Report on Plant – Region 1

**Golden State Water Company
Test Year 2019 General Rate Case
A.17-07-010**

**San Francisco, California
February 16, 2018**

Figure 2-1: Arden System - 2006-2015 Demand in gpm³⁴

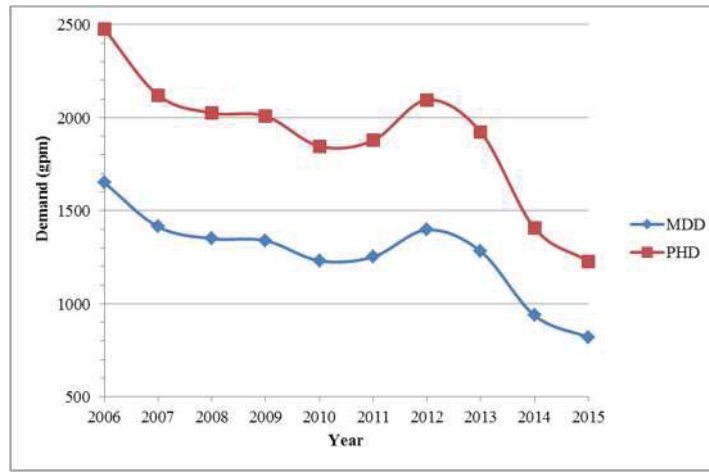
15 Yet, GSWC’s 2016 Arden Master Plan continues to use the 2006 MDD as the basis of its
16 analysis.³³ The figure below shows that the demand of the system has been steadily decreasing
17 since 2006, with a brief increase occurring in 2012.

3 Using the 2006 MDD significantly overstates the system's supply needs,³⁵ resulting in
 4 overbuilding supply infrastructure and increasing rates unnecessarily (*see* also ORA's Report on
 5 Plant – General Issues, Chapter 2). The DDW has indicated that a utility may request a waiver
 6 from the use of the highest MDD in the last 10 years as the basis for projecting demand, as long
 7 as the utility can demonstrate that the alternative MDD value can be as protective, i.e., ensure the
 8 safe and reliable provision of drinking water.³⁶ Moreover, 2006 demand data is no longer part of
 9 the 10-year period that should be under consideration at this time.
